# How to change Mini Card (Half Size) & Cfast to mSATA on GENE-BT05

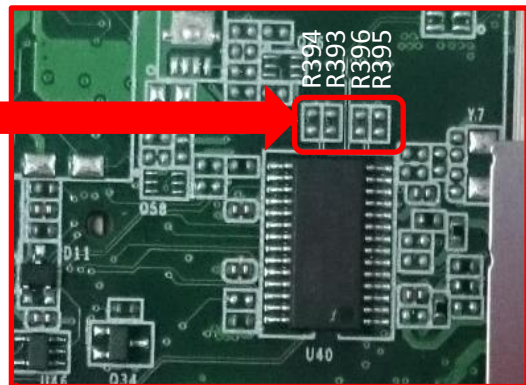
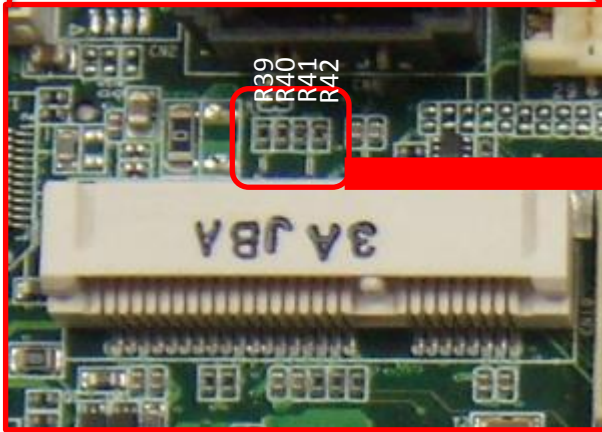
1. Move the 1206 resistor (P/N:1050700002) right by original location. Move R38 to R11.

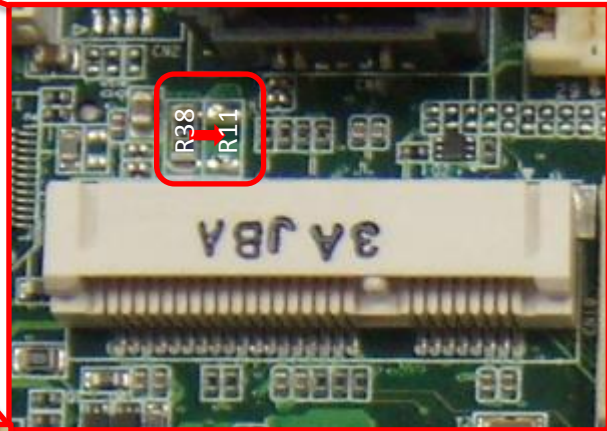
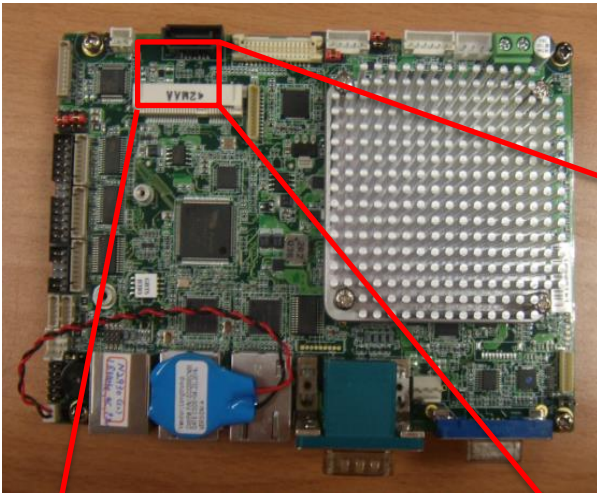
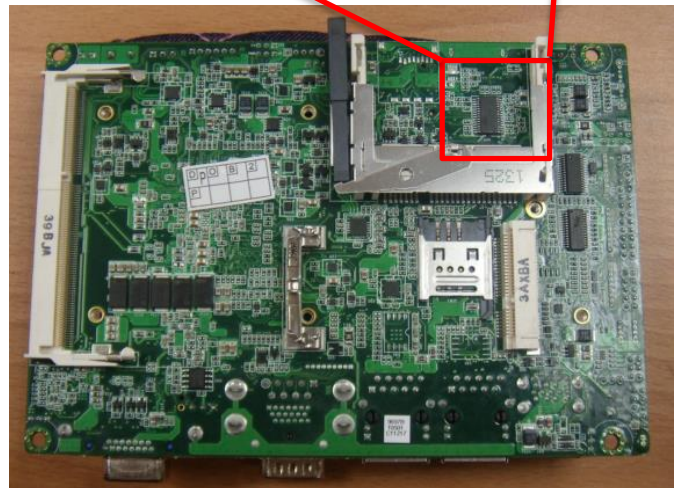
2. Move the 0402 resistors (P/N:105A700009) to Solder side.

- (a) Move R39 to R394.
- (b) Move R40 to R393.
- (c) Move R41 to R396.
- (d) Move R42 to R395.

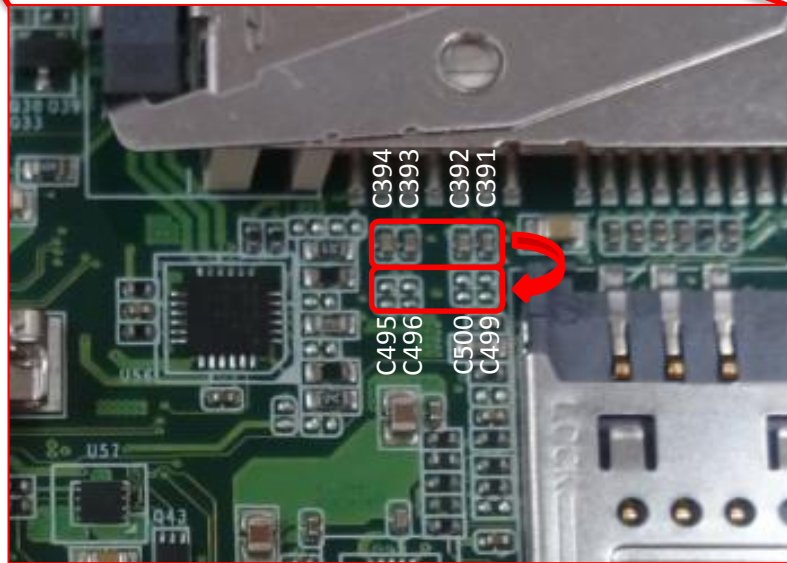
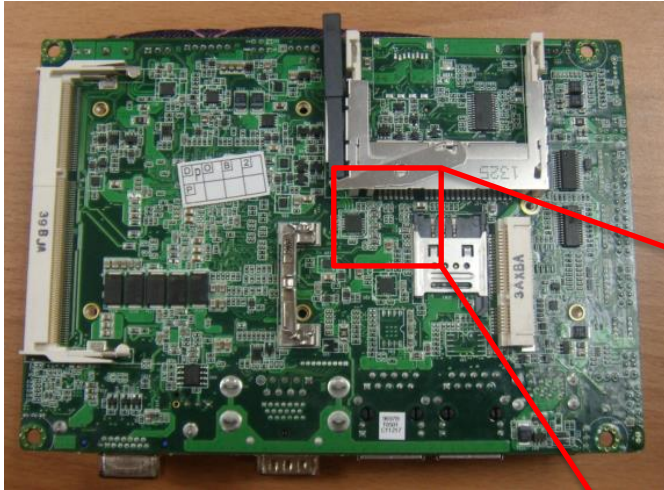
3. Move the 0402 capacitors.  
(P/N:1129701791)
- (a) Move C394 to C495.
  - (b) Move C393 to C496.
  - (c) Move C392 to C500.
  - (d) Move C391 to C499.

4. Remove Cfast Header and Push Ejector(CN33)  
(P/N:1653924110&165390003B)
